HEALTH AND SAFETY AUTHORITY

Re. Advice to Mayo Co.Co. concerning proposed gas terminal.

Copy of HSA submission to Mayo County Council in
respect of proposed gas terminal (planning reference
P03/3343)

This document contains the basis for the findings of the H.S.A. (hereafter referred to as the Authority) with regard to the request for land use planning advice from Mayo County Council for the proposed gas terminal at Bellanaboy Bridge.

Figure 2. Risk profile for Road R314 between Points A & B

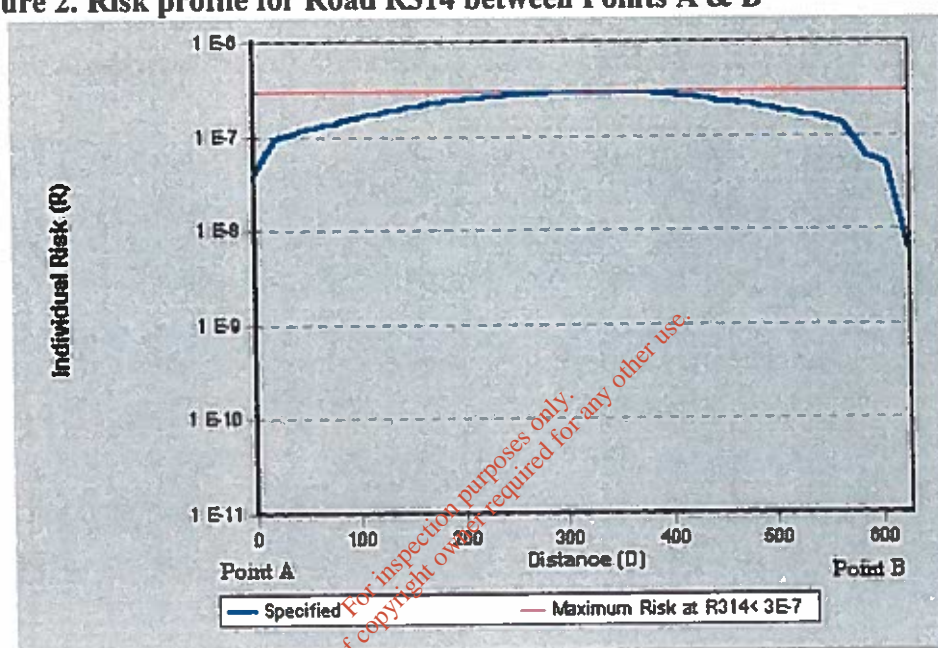
Figure 2 presents the risk profile for the closest 600 meter stretch of the R314 running directly parallel to the Terminal (between Points A & B) and the analysis shows that the maximum risk of dangerous dose posed at the R314 road way is less than 3×10^{-7} / year. This risk level is less than the 1×10^{-6} / year criteria used by the Authority for the nearest residential type property.

Figure 4. Individual Risk of Dangerous Dose at R314 between Points A & B based on Purple Book 25%F

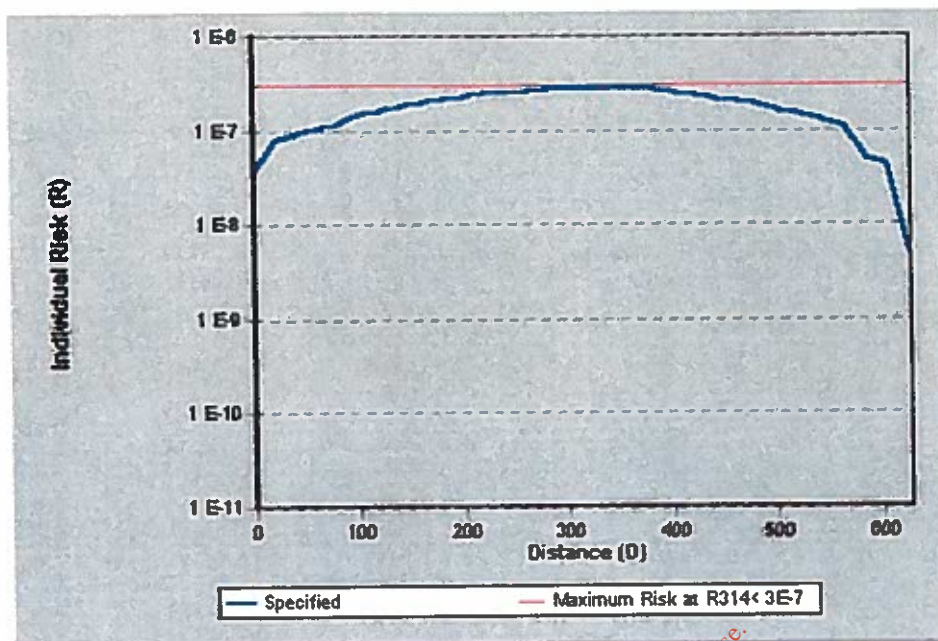
Figure 4 presents the risk profile for the closest 600 meter stretch of the R314 running directly parallel to the Terminal (between Points A & B) and the analysis shows that the maximum risk of dangerous dose posed at the R314 road way is less than 3×10^{-7} / year, which is less than the 1×10^{-6} / year criteria used by the Authority for the nearest residential type property.

Figure 5. Individual Risk of Dangerous Dose –based on HCR 2001

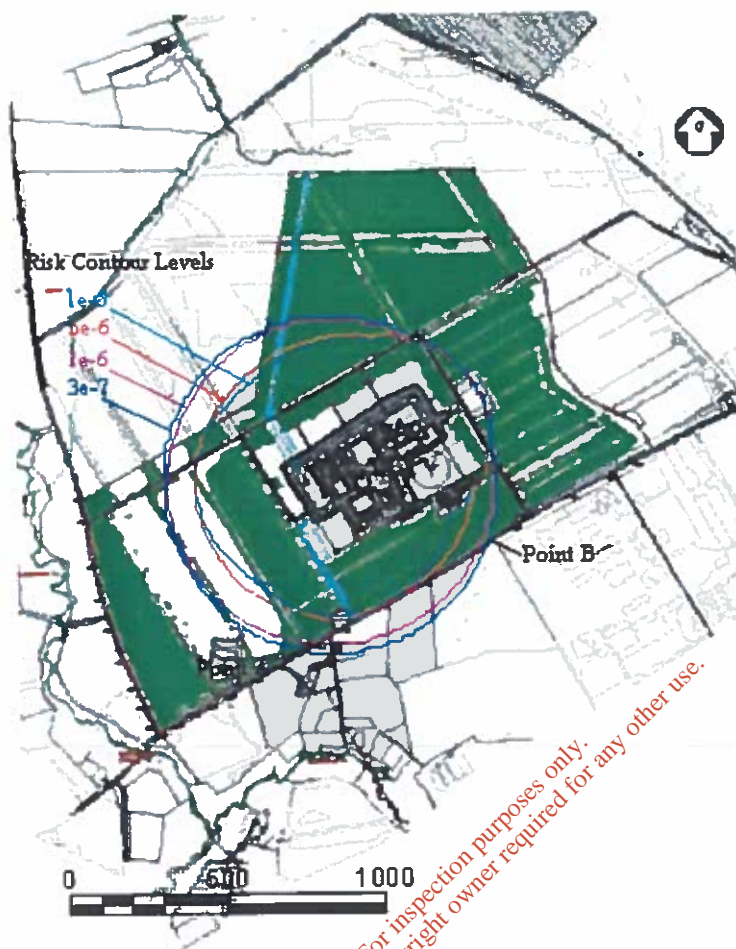
From Figure 5 it can be seen that the risk contours for the 1×10^{-5} down to 3×10^{-7} levels do extend beyond the edge of the landholding at the Northwest corner of the terminal site and also at the southern boundary adjacent to the R314. The contour representing the risk of dangerous dose of 1×10^{-6} / year extends close to the nearest residential type property. The risk of dangerous dose predicted at the nearest property is less than 9×10^{-7} / year, which is less than the 1×10^{-6} / year criteria used by the Authority for the nearest residential type property.

Figure 6. Individual Risk of Dangerous Dose at R314 based on HCR 2001

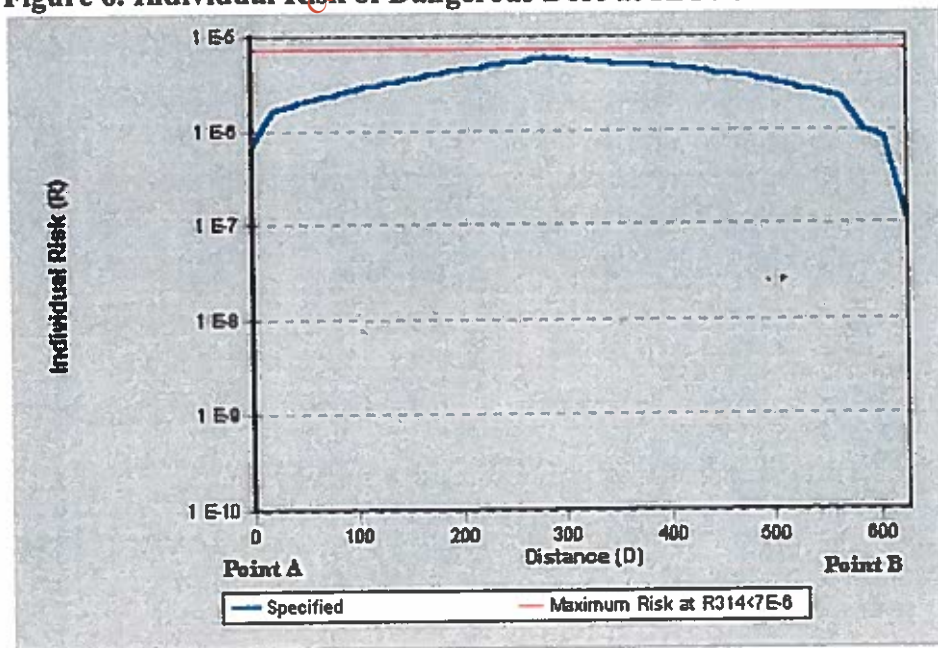
Figure 6 presents the risk profile for the closest 600 meter stretch of the R314 running directly parallel to the Terminal (between Points A & B) and the analysis shows that the maximum risk of dangerous dose posed at the R314 road way is less than 7×10^{-6} / year.

Figure XIII.10 Frequency of Thermal Radiation from Jet Flames ($4\text{kW}/\text{m}^2$) (500 Thermal Dose Units)

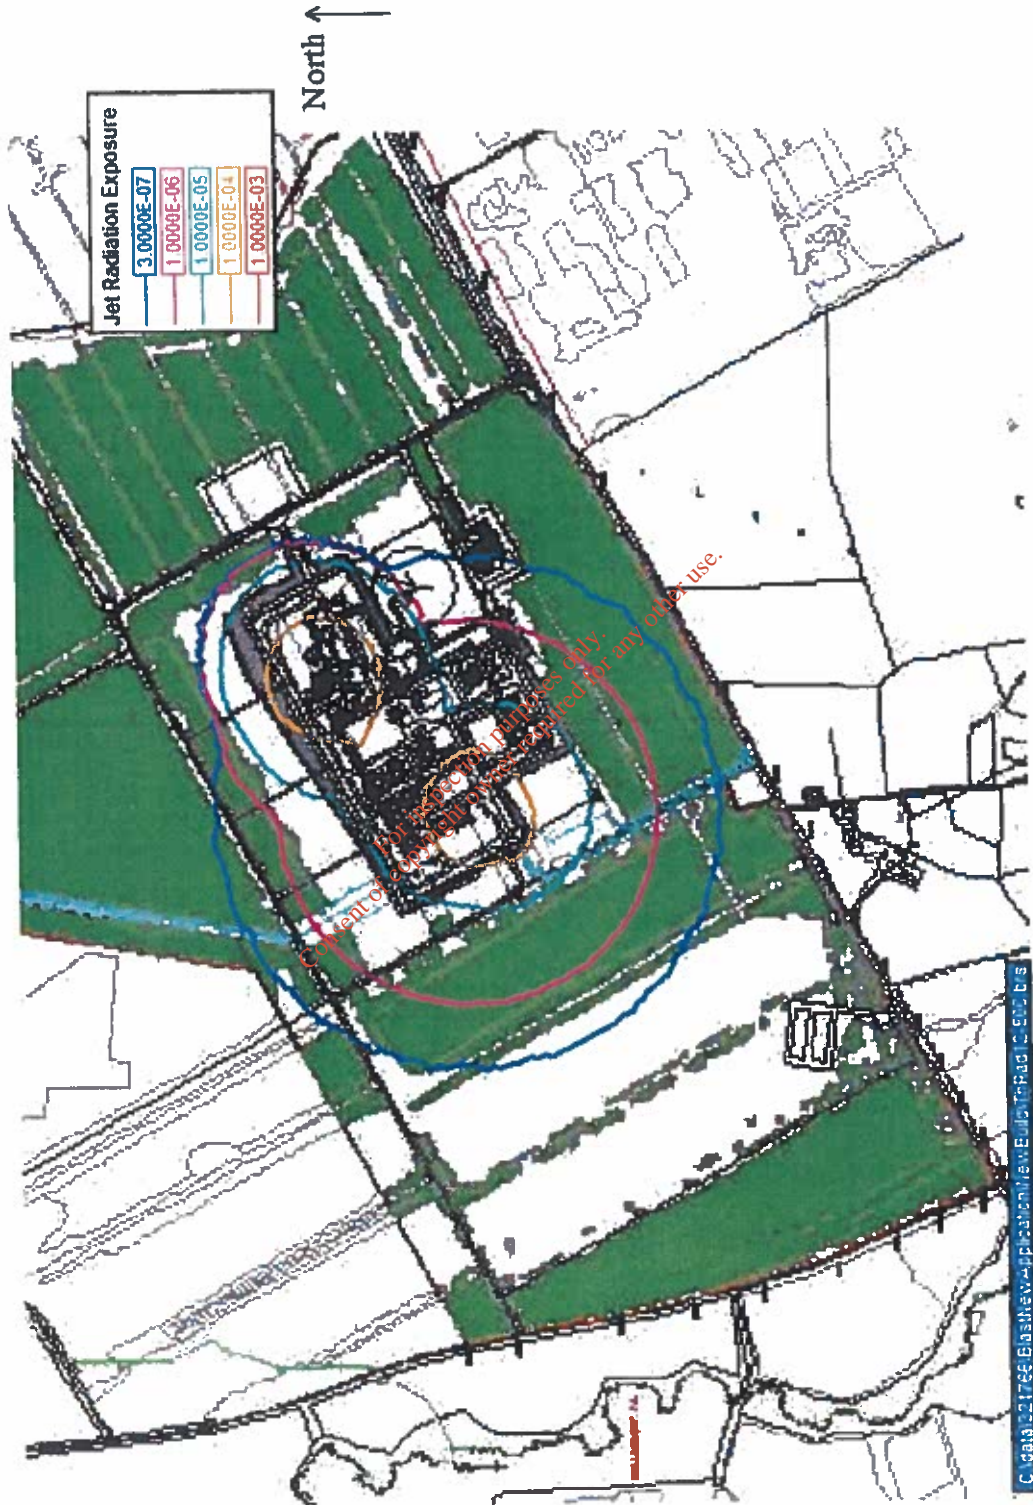
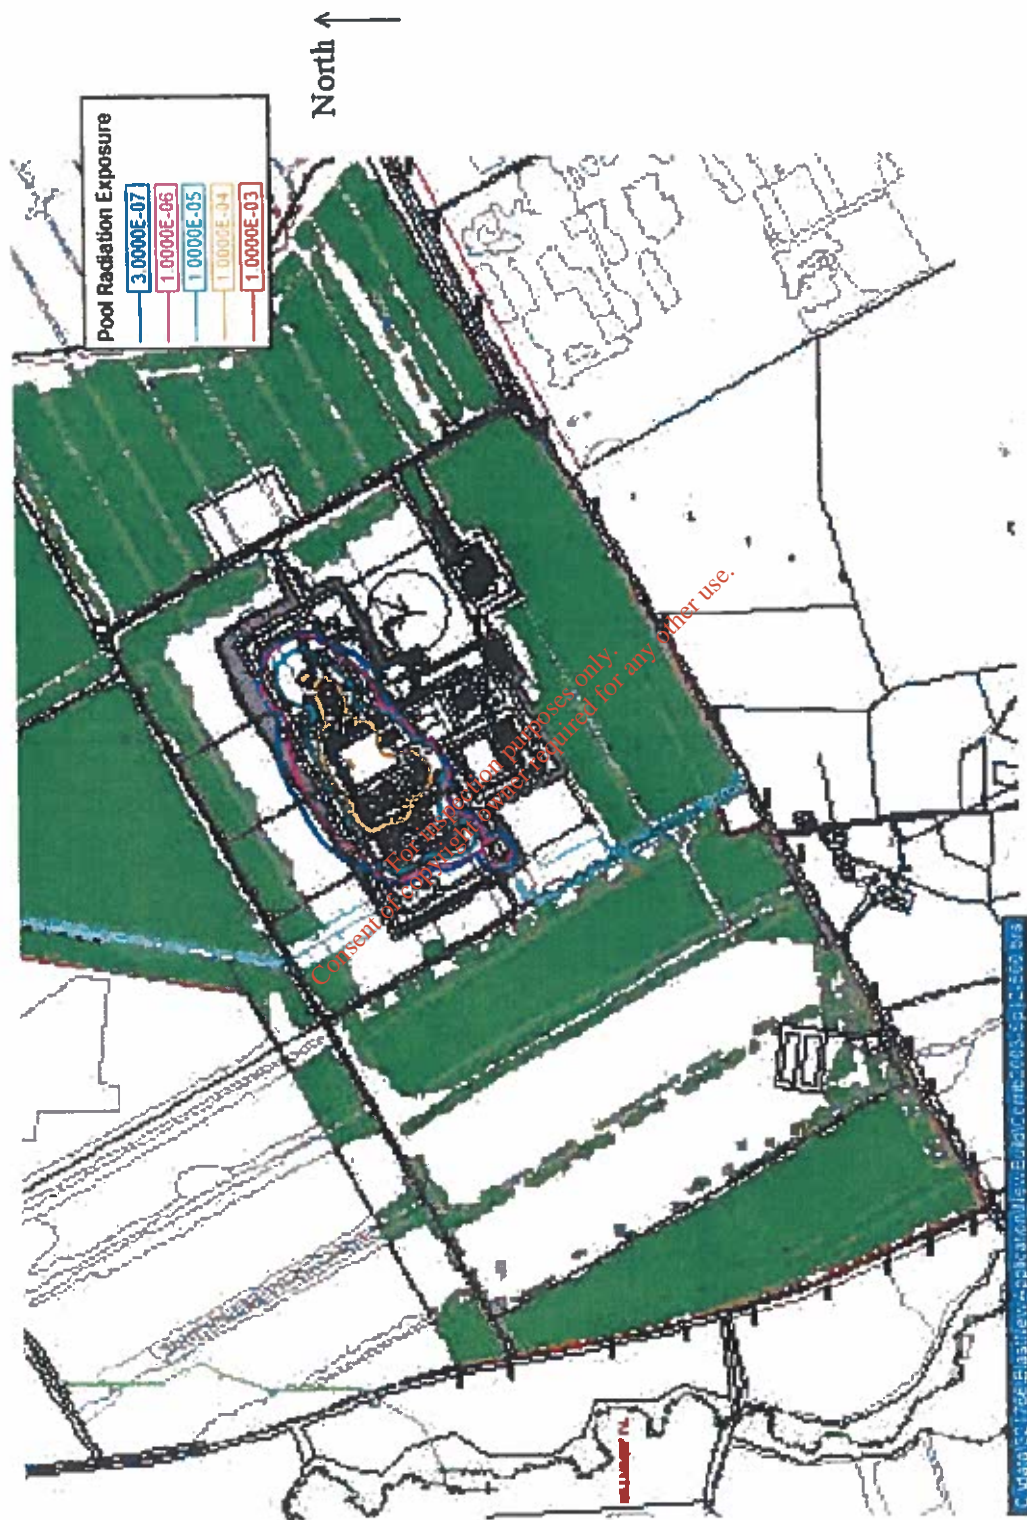
- Overpressures greater than 70 mbar [Figure XIII.2]
- Flash fires [Figure XIII.12]
- Thermal radiation greater than 4 kW/m² from jet or pool fires [Figures XIII.10 and XIII.11]
- Thermal radiation greater than 500 thermal dose units from short duration thermal radiation events [Figure XIII.13]
